SERVICE NO. 1273A BULLETIN

<u>SUBJECT</u>: BULKHEAD MODIFICATION AT FUSELAGE

STATION 317.75

REASON FOR REVISION: SB 1273A specifies Piper Kit No. 764-028 Rev. 10/26/2015,

Figure 1, Sheet 1
Aft Fuselage Inspection Area

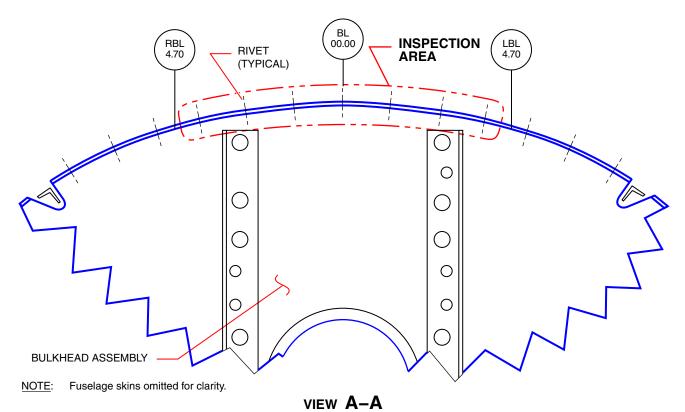
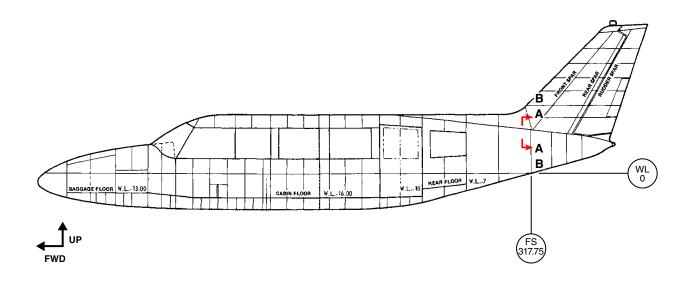
- 1. RC Gain visual access to the bulkhead assembly at FS 317.75, as shown in Figure 1, Sheet 1.
- 2. RC Inspect
 - a. Prior to inspection, wipe surfaces clean using a soft cloth dampened with isopropyl alcohol, mineral spirits, naphtha, or other suitable cleaning agent or method.
 - b. Examine the area shown in View A–A labeled "INSPECTION AREA" for cracks. The inspection shall be accomplished using a 10X magnifier, a mirror and a suitable light source or other equipment capable of providing equal or better resolution.
- 3. RC Assess inspection results
 - a. If a crack is found, follow repair instructions described in Piper Kit P/N 764-028 Rev. 10/26/2015, "Bulkhead Reinforcement and Drag Angle Installation." Repairs must be accomplished prior to next flight.

Figure 1, Sheet 2
Aft Fuselage Inspection Area

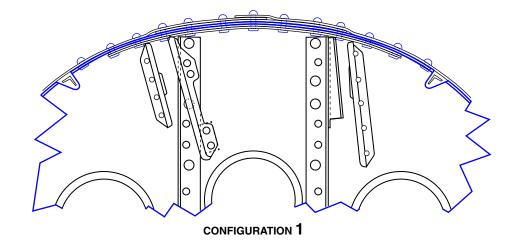
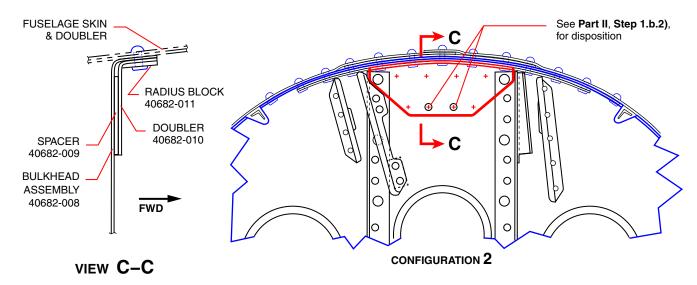
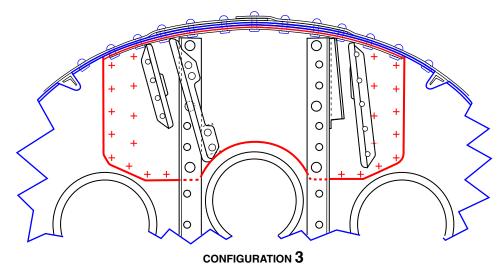
- 1. RC Examine the existing configuration of the bulkhead assembly at FS 317.75. Match it with one of the three configurations shown in View B–B. Complete Step a., b. or c., depending on the existing configuration.

- 1) Remove these parts from the airplane, and discard:
 - P/N 40682-009 Spacer
 - P/N 40682-010 Doubler Reinforcement
 - P/N 40682-011 Block Radius
 - 2) Removal of the parts listed in Step 1), above, results in two (2) open holes not addressed by the instructions in Piper Kit P/N 764-028 Rev. 10/26/2015. These holes are identified in View B–B, illustration "Configuration 2" with the text "See Part II, Step 1.b.2), for disposition."

- a. Configuration 1: Order Piper Kit P/N 764-028 Rev. 10/26/2015, "Bulkhead Reinforcement and Drag Angle Installation," and install per kit instructions.

- b. Configuration 2: Order Piper Kit P/N 764-028 Rev. 10/26/2015, "Bulkhead Reinforcement and Drag Angle Installation," and install per kit instructions, with the following exceptions:

- a) At the two fastener locations, match drill 0.144 inch diameter holes in the new P/N 71681-002 Reinforcement Doubler to match existing holes in the P/N 40682-008 Bulkhead Assembly.

- b) Install NAS1739B4-3 rivets (or other industry standard rivets of equivalent or higher strength) through the reinforcement doubler and bulkhead assembly.

- Configuration 3: No rework is required. Piper Kit P/N 764-028, "Bulkhead Reinforcement and Drag Angle Installation," has already been installed.
- 2. Make a logbook entry documenting compliance with Part II of this service bulletin.
